World Forum for Harmonization of Vehicle Regulations**Working Party on Automated/Autonomous and Connected Vehicles****Seventh session**

UN Regulations Nos. 13, 13-H, 139, 140 and UN GTR No. 8:**Clarifications****Proposal for Supplement 17 to the 11 series of amendments
to UN Regulation No. 13 (Heavy vehicle braking)****Submitted by the expert from the European Association of Automotive
Suppliers***

The text reproduced below was prepared by the expert from the European Association of Automotive Suppliers (CLEPA) to include in UN Regulation No. 13 requirements for the type approval of Electro-Mechanical Braking (EMB) systems as state-of-the-art braking systems. The modifications to the existing text of the Regulation are marked in bold for new and strikethrough for deleted characters.

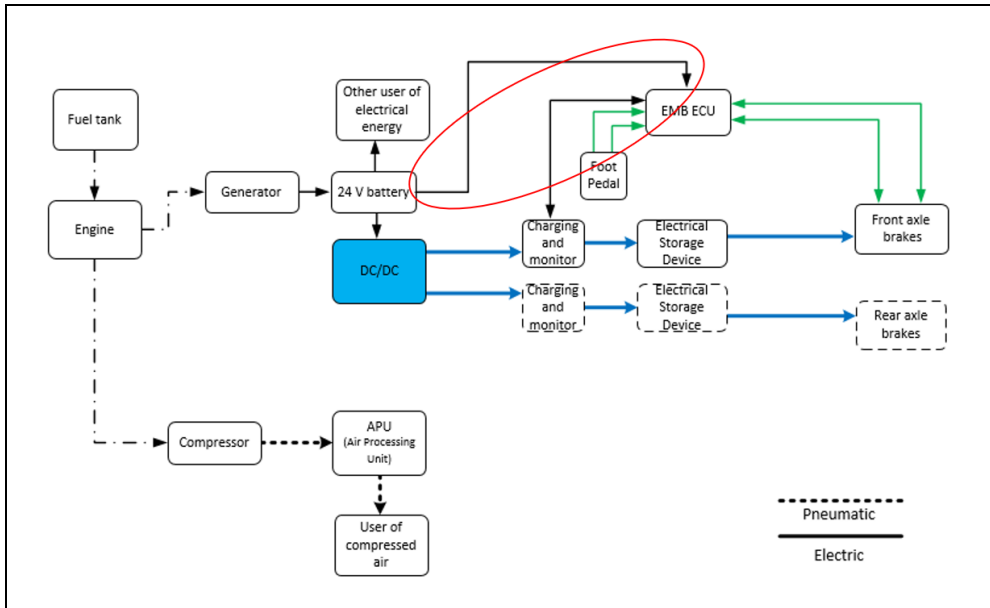
- 5.2.1.34. Special additional requirements for service braking systems with electro-mechanical braking system with electric transmission**
- 5.2.1.34.1. For electro-mechanical braking systems, the requirements of this paragraph 5.2.1.34. apply instead of those of paragraph 5.2.1.27. above.**

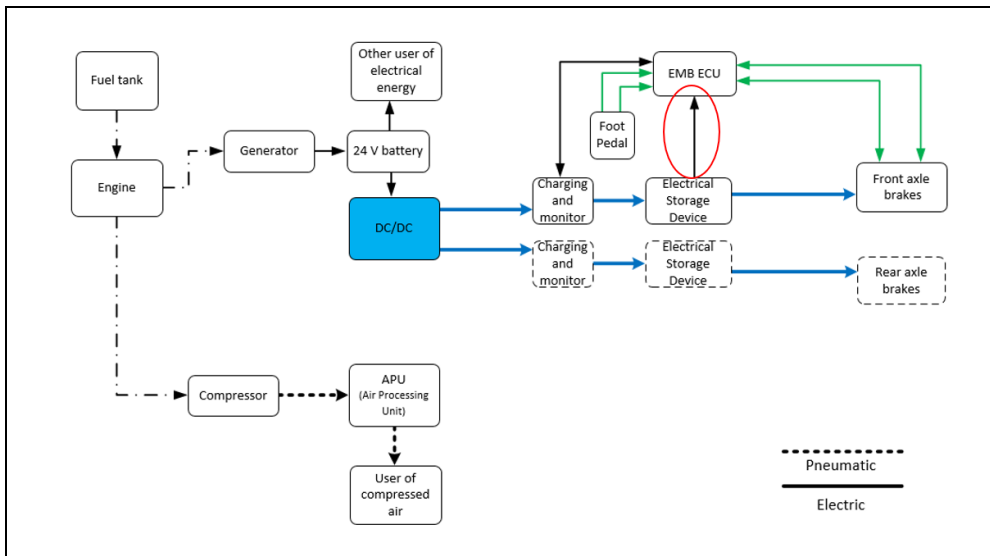
- 5.2.1.34.5. With an electrical energy supply feeding only the electric control transmission and in the event of a failure of the energy source of the electric control transmission, starting from the nominal value of the energy level, the full control range of the service braking system shall be guaranteed after twenty consecutive full stroke actuations of the service braking control. During the test, the braking control shall be fully applied for 20 seconds and released for 5 seconds on each actuation. It should be understood that during the above test, sufficient energy is available in the energy transmission to ensure full actuation of the service braking system. This requirement shall not be construed as a departure from the requirements of Annex 7, Part D.**

40. Paragraph 5.2.1.34.5. addresses a configuration of an electro-mechanical braking system where an electrical energy storage device (e.g. battery) **only** supplies energy to the **control** transmission (but **not** to the electrical energy transmission as in the case with an EBS which has to comply with paragraph 5.2.1.27.5.); as an exemplary braking system see figure in paragraph 5.2.1.34.5.).

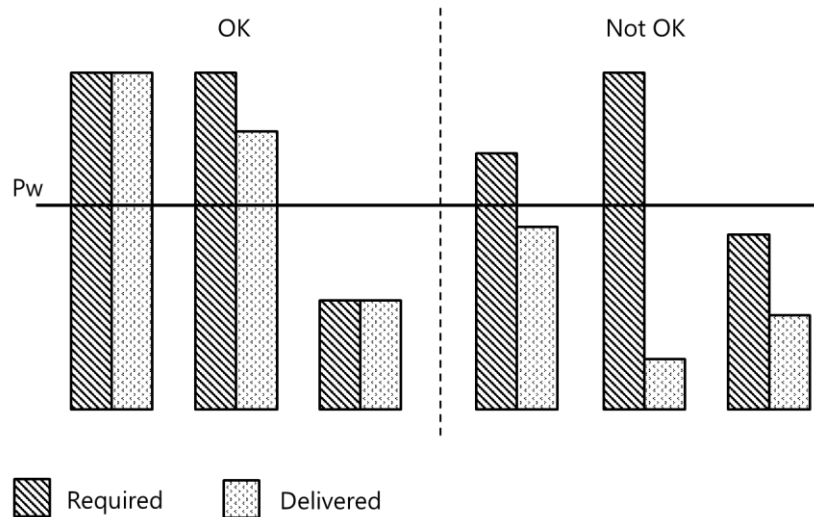
5.2.1.34.6. In the case that the electrical energy storage devices are also providing electrical energy for the electrical control transmission, the requirements of paragraph 1.2.1. of Part D of Annex 7 shall apply.

41. In contrast to paragraph 5.2.1.34.5., this requirement addresses a configuration of an electro-mechanical braking system where energy storage devices are providing electrical energy for the electrical control and electrical energy transmission; as an exemplary braking system see figure in paragraph 5.2.1.34.6.).
